Access Compliance Report

Public Rights-of-Way

Intersection ID: 46734	Main Street: BOBHOUSE_DR	Cross Street: THREATT_WOODS_DR	Location: NE
ADA ID: CDB989E76C2C	Ramp Type: PerpDiag	Initial Pass/Fail: Fail	Overall Compliance: No
Severity Score: 13.75			
Codes/Mitigation Info/Possible Solution		Field Measurements/Component Compliance

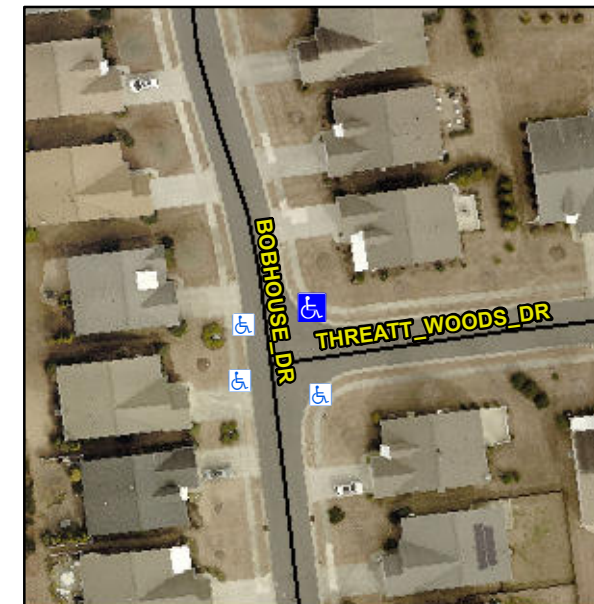
Not Found, R304.2.2, R304.5.3

Compliance	Description	Data	Compliance	Description	Data
N/A	Ramp Length (in)	48.5	No	Ramp Slope (%)	8.5
Yes	Ramp Width (in)	48.0	No	Ramp XSlope (%)	4.5
N/A	Flare Type LT	N/A	N/A	Flare Type RT	N/A
N/A	Flare Slope LT (%)	N/A	N/A	Flare Slope RT (%)	N/A
N/A	Flare Traversable LT?	N/A	N/A	Flare Traversable RT?	N/A
N/A	Landing Length (in)	N/A	N/A	DWS Provided?	N/A
N/A	Landing Width (in)	N/A	N/A	DWS Contrast?	N/A
N/A	Landing Slope (%)	N/A	N/A	DWS Length (in)	N/A
N/A	Landing X Slope (%)	N/A	N/A	DWS Full Width?	N/A
N/A	Landing Curb? (Y/N)	N/A	N/A	DWS Offset (in)	N/A
N/A	Shared Landing?	N/A			
N/A	Gutter Ponding?	N/A	N/A	Gutter Slope (%)	N/A
N/A	Gutter Lip Ht (in)	N/A	N/A	Gutter X Slope (%)	N/A
N/A	Painted X Walk1?	No	N/A	Painted X Walk2?	No
	X Walk 1 Direction	To W		X Walk 2 Direction	To S
N/A	X Walk 1 Width (in)	N/A	N/A	X Walk 2 Width (in)	N/A
	X Walk 1 Slope (%)	3.7		X Walk 2 Slope (%)	1.7
	X Walk 1 X Slope (%)	2.1		X Walk 2 X Slope (%)	2.6

Remove & Replace Curb Ramp With Two New Directional Ramps or Equivalent.
